Recall Bulletin

PRODUCT EMISSION RECALL

SUBJECT: Oxygen Sensor Fracture

MODELS: 2011-2013 Chevrolet Express
2011-2013 GMC Savana
Cutaway Equipped with Gasoline Engine

(A) First Design Heated Oxygen Sensor (B) Second Design Heated Oxygen Sensor (1) Location of Part Number

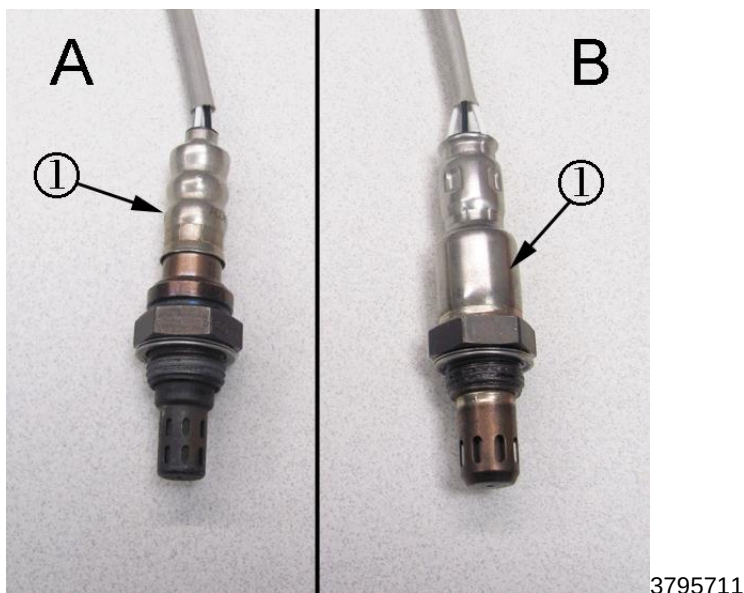
3. Determine if a first design (A) or second design (B) heated oxygen sensor is installed using a light and mirror.
 - If a second design (B), P/N 12637297, heated oxygen sensor is installed, no further action is required. Lower the vehicle. Refer to *Lifting and Jacking the Vehicle* in SI.
 - If a first design (A), P/N 12656071 or P/N 12612571, heated oxygen sensor is installed, remove the sensor and replace it with a second design heated oxygen sensor. Refer to *Heated Oxygen Sensor Replacement –Bank 2 Sensor 1* in SI and *Heated Oxygen Sensor Replacement –Bank 2 Sensor 2* in SI.
